TO: Hardy County Health Department, Moorefield, W.V.

FROM: Name Hunter Co. of WV Phone 1-304-262-2770Address 1800 West King St. Martins WV 25401RE: Property Location Ashton Woods Sub.

Request is hereby made for a site investigation to determine the suitability of the subject property as a site for the small sewage system indicated below:

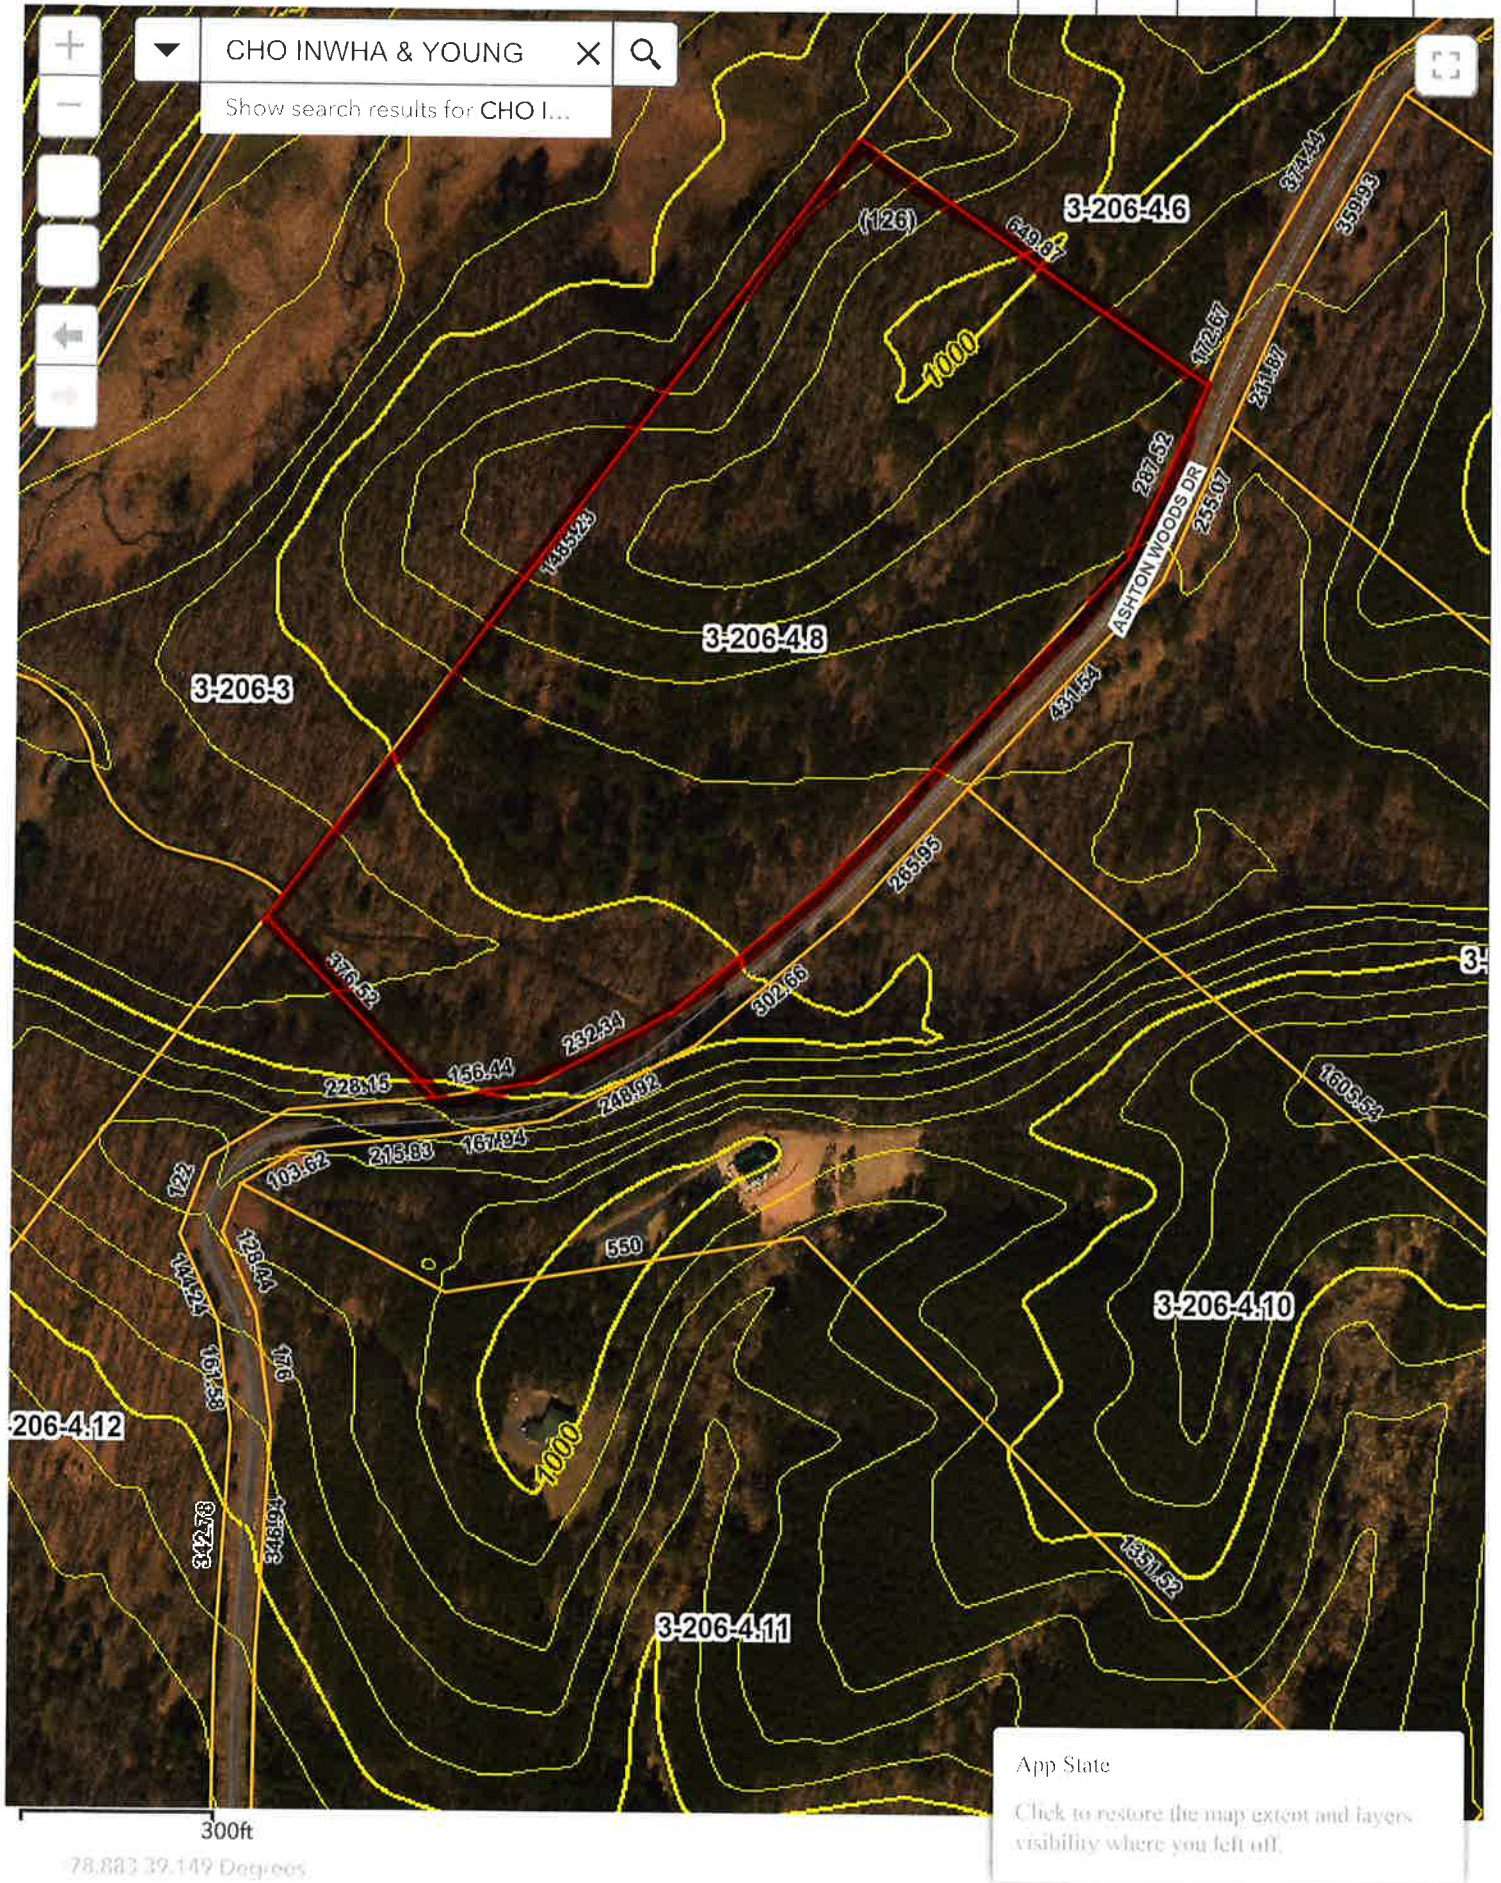
This is to certify that the Hardy County Health Department reviewed the contents of this form and conducted a site visit on subject property. Based on the information provided it is the opinion of the undersigned that this site (X) is ~~() is not~~ suitable for the installation of the small sewage system indicated.Signature Louise H. Thompson, R.S. Date 6-23-03Title Sanitarian

Water 12"

NOTICE: Water in the 6-ft observation hole indicates a potential problem with ground water movement on this site. A french drain may be required to intercept water.
